Authorized Field Change

AFC 16903R1

Subject: ISB Starter

Model: CE Bus

Figure 1. Engine Compartment – Cowl

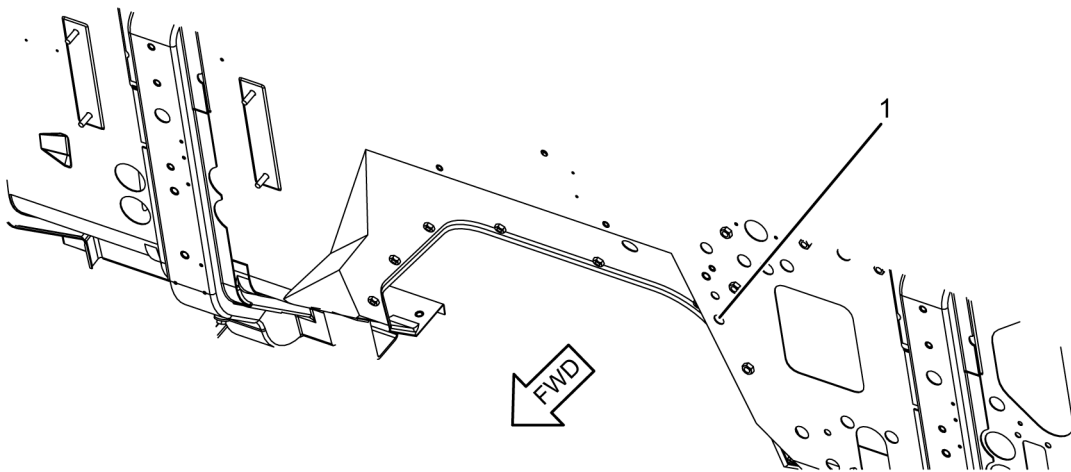
1. Plug
6. Working from engine compartment, remove plug (Figure 1, Item 1) from cowl. Clean area around hole.

Figure 2. 1601 Connector

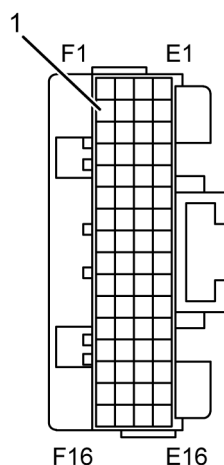
10. Access Body Control Module (BCM).
 11. Locate and disconnect 1601 Connector from BCM.
 12. Unlock connector. Populate kit-supplied harness terminated end into Cavity F2 (Figure 2, Item 1) and lock connector.
 13. Connect BCM connector 1601. Ensure connector is properly secured and connector lock is engaged.
 14. Insert recently populated harness into convoluted loom.
- NOTE: Secure harness away from moving parts or sharp edges.**
15. Route harness from BCM through hole into engine compartment and secure using cable ties.

Figure 3. 4009 Relay Connector

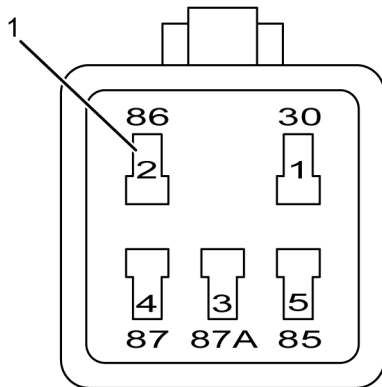
16. Connect ground cable to negative terminal located on main vehicle battery.
17. Locate Transmission Control Module (TCM) neutral switch relay on cowl bracket.
18. Verify circuit K92#141 has 12V power in Neutral / Park only.
19. Disconnect relay. Remove terminal lock from relay composite connector and remove circuit K92#141 located in Cavity 2 / 86 (Figure 3, Item 1).
20. Populate opposite side of kit-supplied harness terminated end into K92#141 located in Cavity 2 / 86. Install terminal lock into relay composite connector and reconnect relay.
21. Using RTV silicone sealant, seal wire pass-through area in engine compartment.
22. Secure harness to existing engine / vehicle harness using cable ties.
